ADDENDUM #1

DATED: DECEMBER 23, 2025

**PROJECT: New Fleet Management Building for AIDT
Montgomery, Alabama**
PH&J No: 2502GVA
DCM No: 2025417

Attachment #1: Revised Drawing M1.1

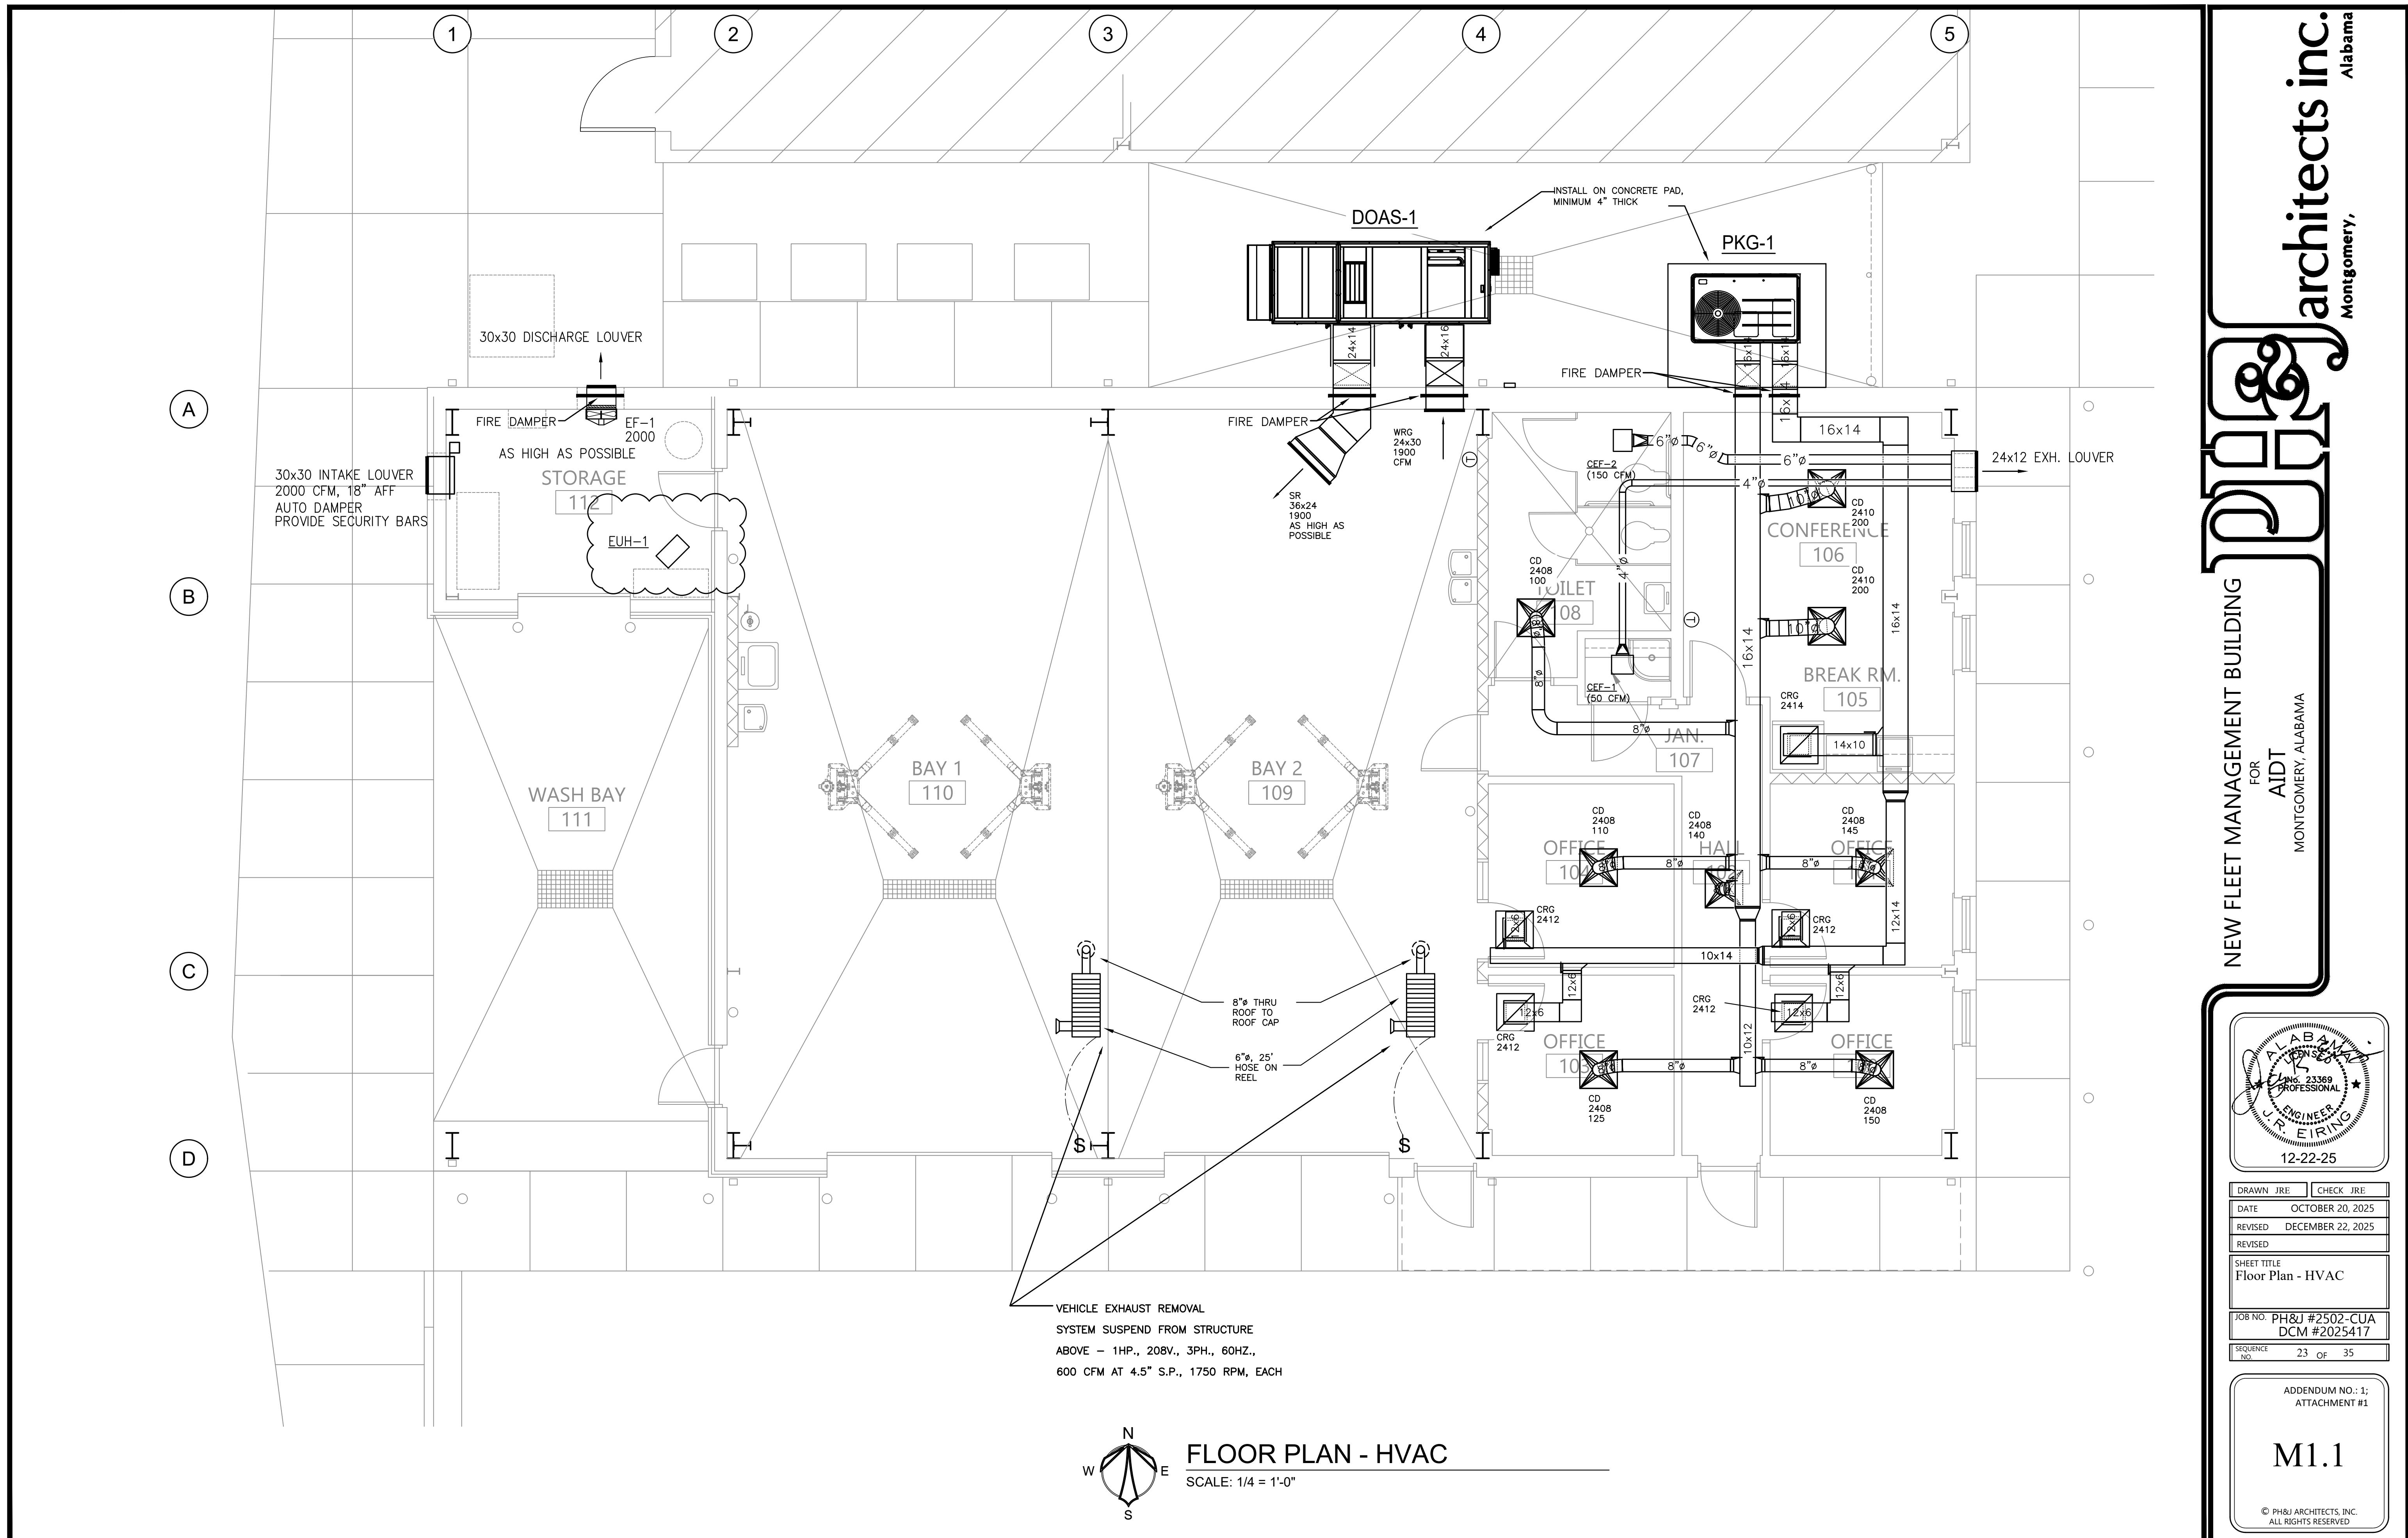
1. **Electric Unit Heater** (Drawing M1.1): Provide electric unit heater in location shown on Attachment No. 1 (EUH scheduled on sheet M2.1).
2. **Scheduled HVAC Unit "DOSA-1** (Drawing M2.2): Add additional note to scheduled unit shown on Attachment No. 2.
3. **Power Plan** (Drawing E3.1): Change all designated home run circuits from "RP1" to "SE".
4. **Mechanical Power Plan** (Drawing E3.2): Add electric unit heater to mechanical power plan and "General Equipment Schedule" as shown on Attachment No. 3.
5. **Panelboard Schedule** (Drawing E5.2): Add additional circuit and load to schedule as shown on Attachment No. 4.
